FINAL PRODUCT/PROCESS CHANGE NOTIFICATION #16556

Issue Date: 12-Oct-2011**TITLE:** LFBGA Mold Compound and Epoxy Change in ATP3**PROPOSED FIRST SHIP DATE:** 12-Jan-2012**AFFECTED CHANGE CATEGORY(S):** Mold Operation – New Mold Compound**FOR ANY QUESTIONS CONCERNING THIS NOTIFICATION:**Contact your local ON Semiconductor Sales Office or Sarah Sanico < ffxxxh@onsemi.com >**SAMPLES:** Contact your local ON Semiconductor Sales Office**ADDITIONAL RELIABILITY DATA:** AvailableContact your local ON Semiconductor Sales Office or Phine Guevarra < phine.guevarra@onsemi.com >**NOTIFICATION TYPE:**

Figure 1. Acoustic Microscopy Image prior Moisture Resistance test.

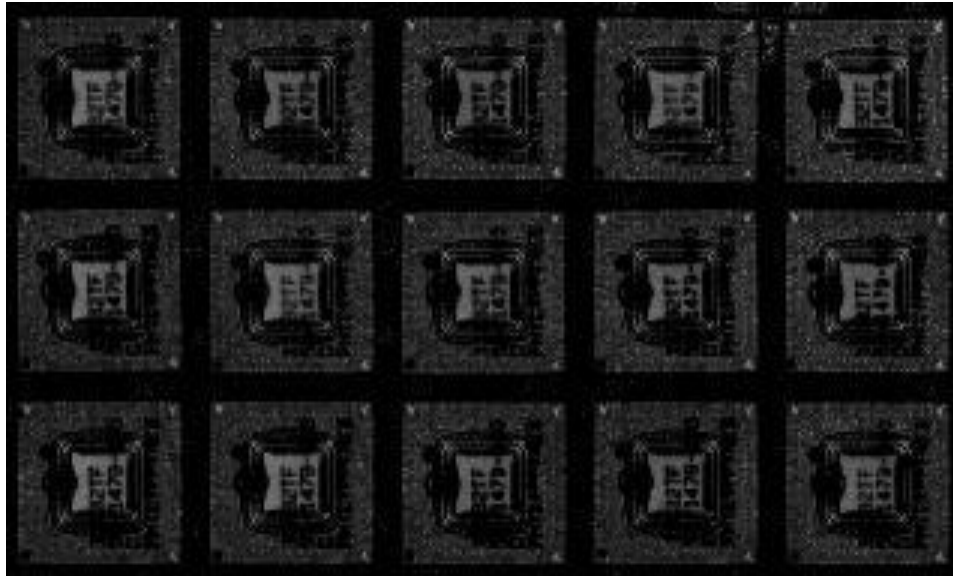
TEST	CONDITIONS	CHECKPOINTS	RESULT
Moisture Preconditioning <ul style="list-style-type: none"> Bake Humidity Soak Reflow 	125°C 30°C / 60% RH 225°C	21 hrs 192 hrs 3 cycles	PASSED
Scanning Acoustic Microscopy	Not Applicable	Pre and Post MSL	PASSED (see Figure 1 and 2)
Temperature Cycling	-55°C/125°C	1000 cycles	PASSED
Preconditioning Temperature Cycling	-55°C / 125°C	100 cycles	PASSED
Temperature Humidity Unbiased	85°C / 85% RH	1000 hrs	PASSED
High Temperature Bake	150°	500 hrs. 1000 hrs	PASSED
Bond Pull Test	Not Applicable	Not Applicable	PASSED (see Figure 4)
Bond Shear Test	Not Applicable	Not Applicable	PASSED (see Figure 5)
Solder ball Shear Test	Not Applicable	Not Applicable	PASSED (see Figure 6)
Electrical Testing	SW3, 70°C	Not Applicable	PASSED
External Visual	Not Applicable	Not Applicable	PASSED (see Figure 7)
X-ray Inspection	Not Applicable	Not Applicable	PASSED
